Nevro Corp.  
Ex. 1002  
U.S. Patent No. 7,891,085

**RESPONSE TO NOTICE TO FILE CORRECTED APPLICATION PAPERS**

**IDENTIFICATION OF DRAWING DEFICIENCIES**

**FIG. 5A**

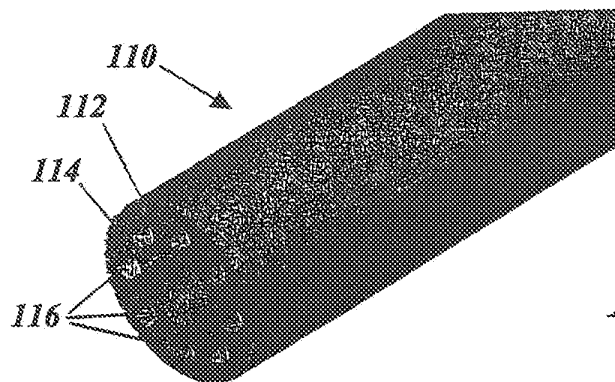
- Figure numbers are duplicated or missing. FIG(s)
- Drawing sheet or figure is missing. FIG(s)
- Numbers, letters, or reference characters in the drawing have been crossed out or are illegibly handwritten. FIG(s) 5a, 5b, 5c, 6a, 6b

In response to the Notice to File Corrected Application Papers -- Notice of Allowance Mailed, dated November 24, 2010, Applicants respectfully submit replacement drawings (5 figures, 2 sheets).

FIG. 6A

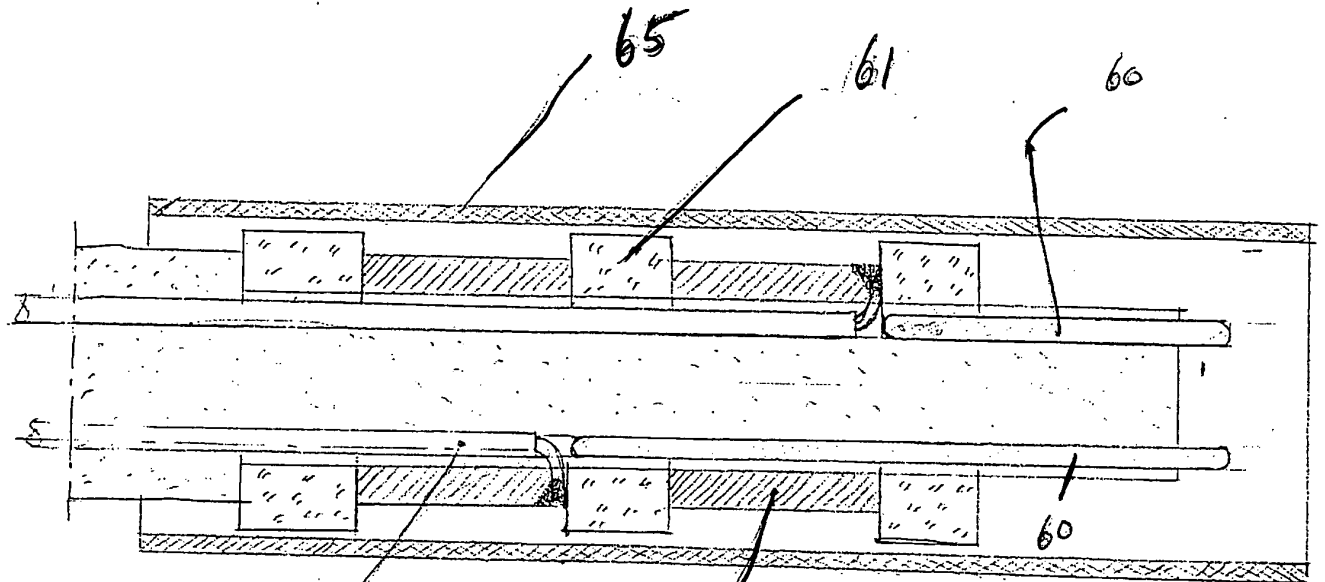
- Figure numbers are duplicated or missing. FIG(s)
- Drawing sheet or figure is missing. FIG(s)
- Numbers, letters, or reference characters in the drawing have been crossed out or are illegibly handwritten. FIG(s) 5a, 5b, 5c, 6a, 6b
